**BELL BEND NUCLEAR POWER PLANT
BBNPP PLOT PLAN CHANGE COLA
SUPPLEMENT, PART 3 (ER); SECTION 3.7
BNP-2010-272 Docket No. 52-039**

Revised BBNPP COLA Part 3 (ER), Section 3.7, Revision 2a

3.7 POWER TRANSMISSION SYSTEM

Figure 3.7-1— BBNPP Site 500 kV and 230 kV Regional Circuit Corridors

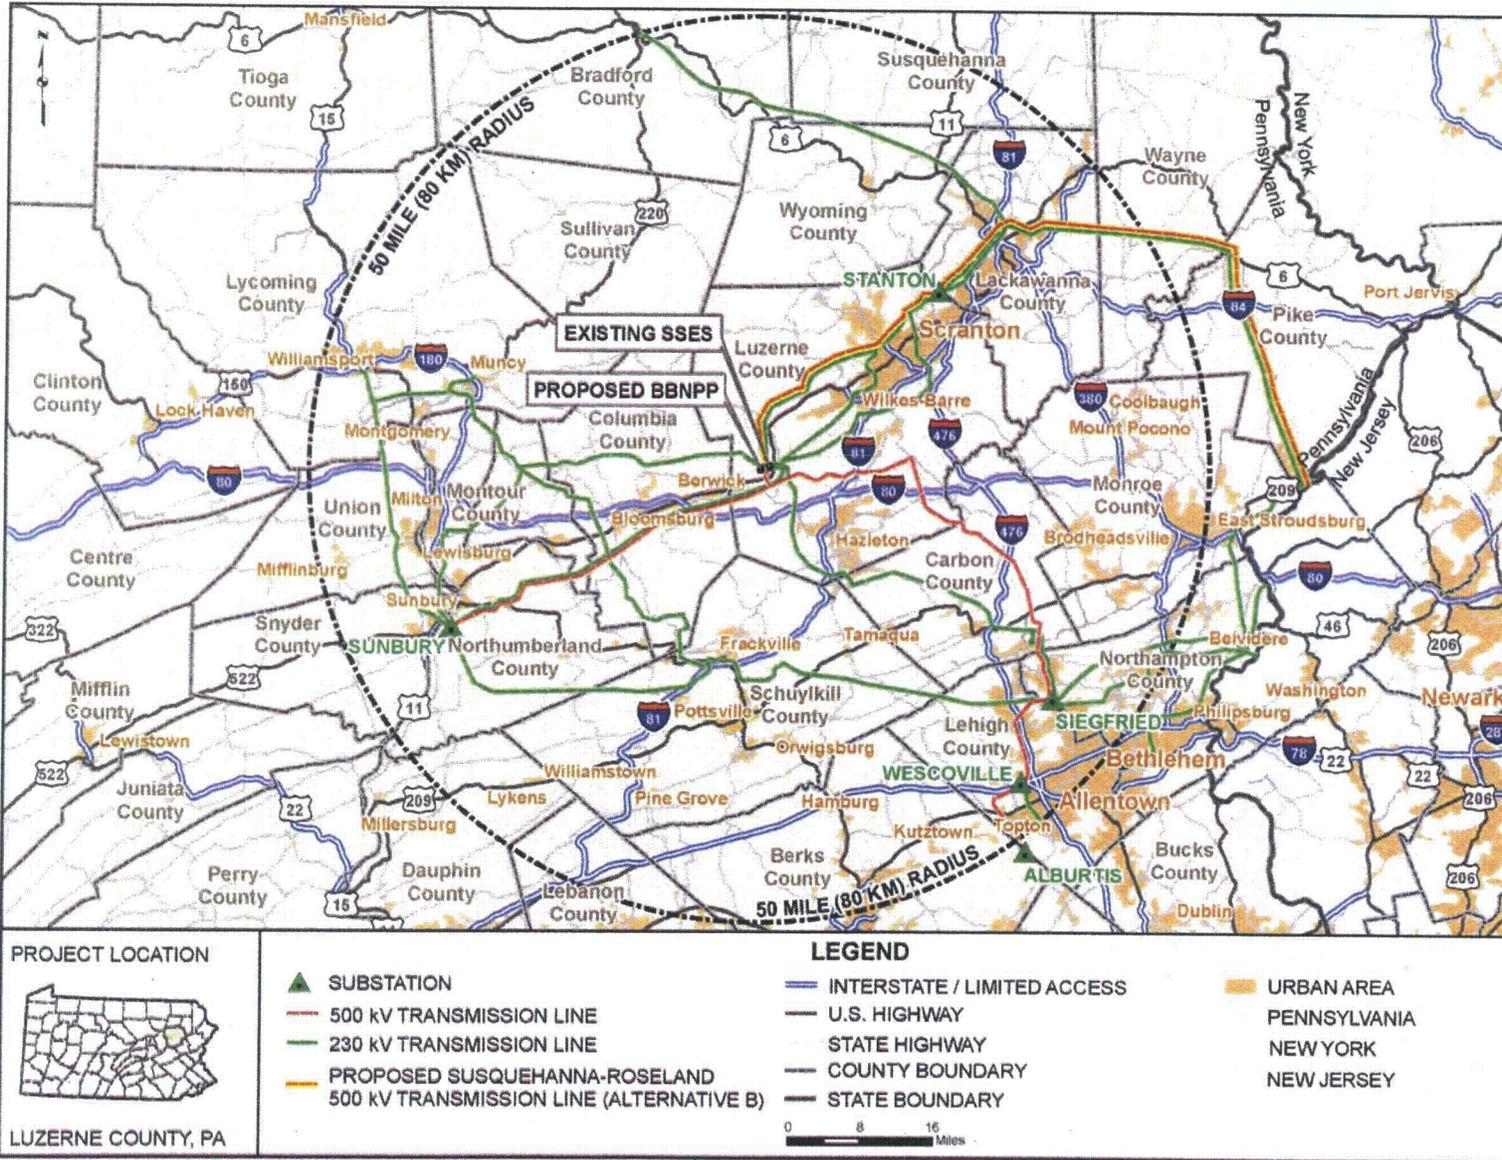
The BBNPP Switchyard will occupy a tract of land of approximately 300 ft (91.4 m) by 846 ft (257.9 m), or 5.8 acres (2.4 hectares). The switchyard is located approximately ~~300~~1400 ft (91.4~~(426.7)~~ m) east of the ~~plant transformer bay, 1250~~BBNPP containment, 2400 ft (381.0 m) (731.5m) from the south plant boundary and ~~1300~~1800 ft (396.2~~(548.6)~~ m) from the ~~northwest~~north plant boundary, and can be seen on Figure 3.7-2.
